# University of Kentucky<sup>®</sup>

CCK-2564.0-9-24

Construct Health Education Building

ADDENDUM #3

C401

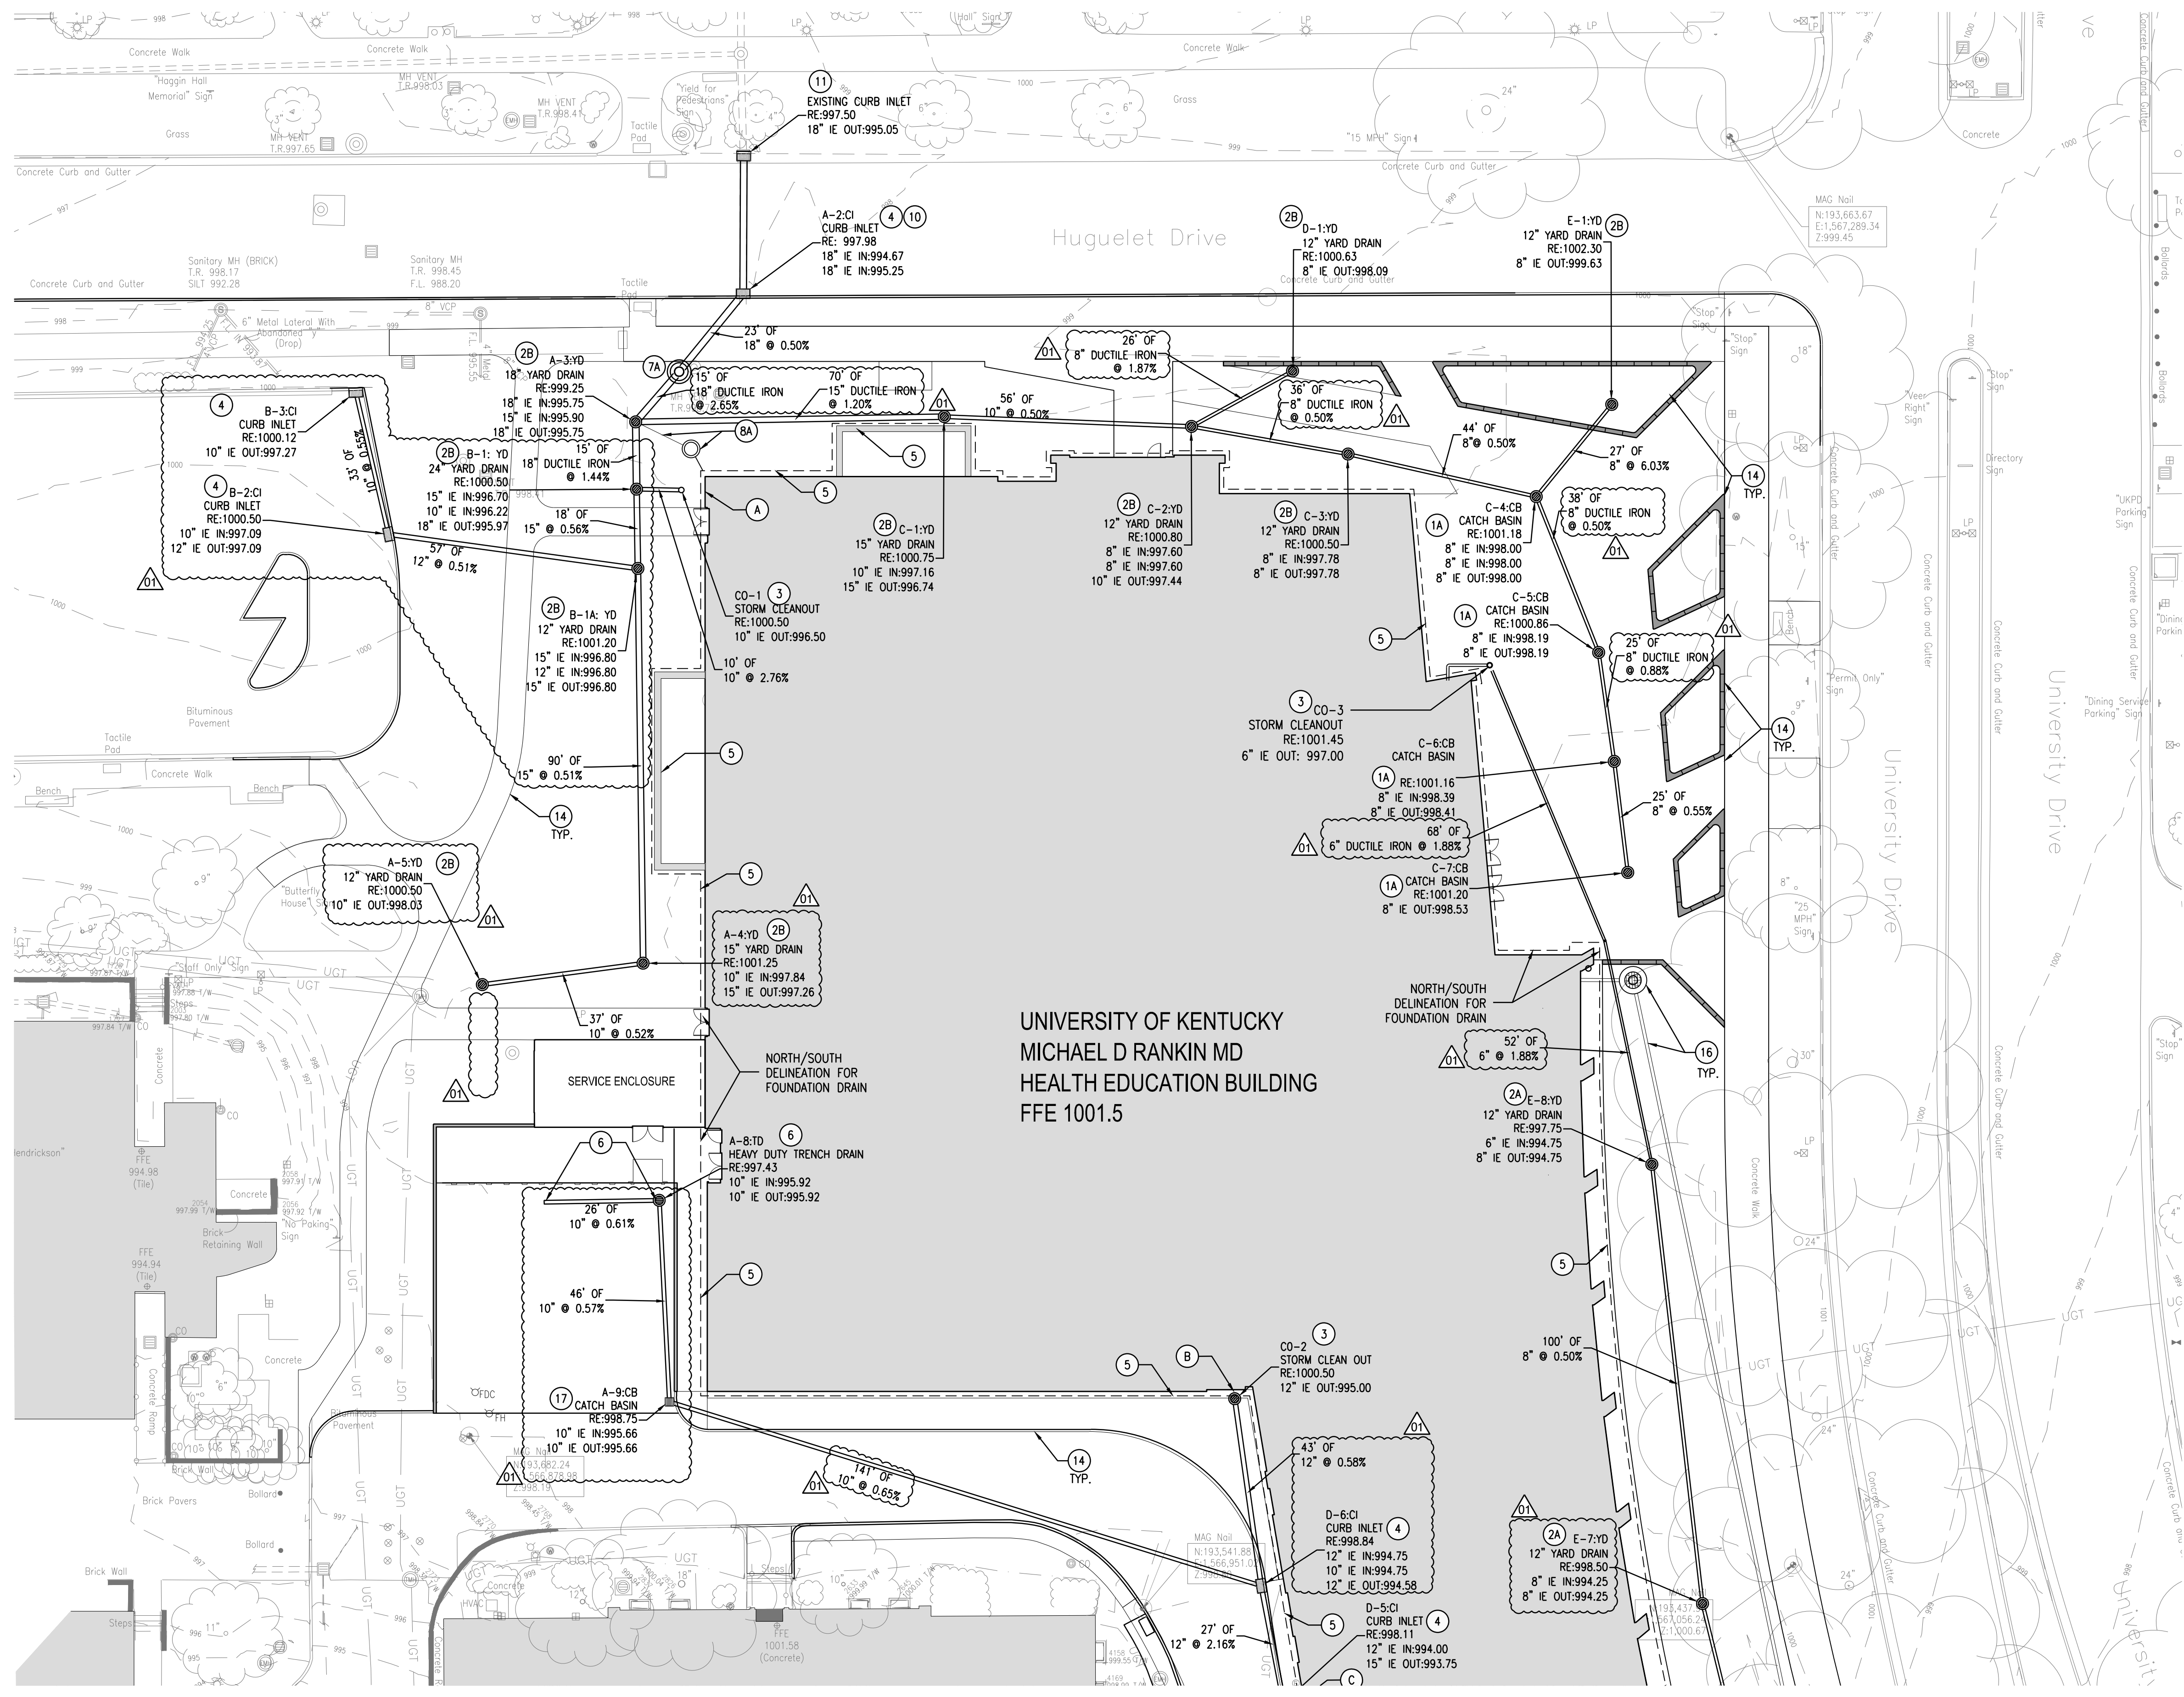
Refer to Sheet C401 – Site Water Utility Plan. Coded Note 8 Changed. "Contractor" replaces "Owner".
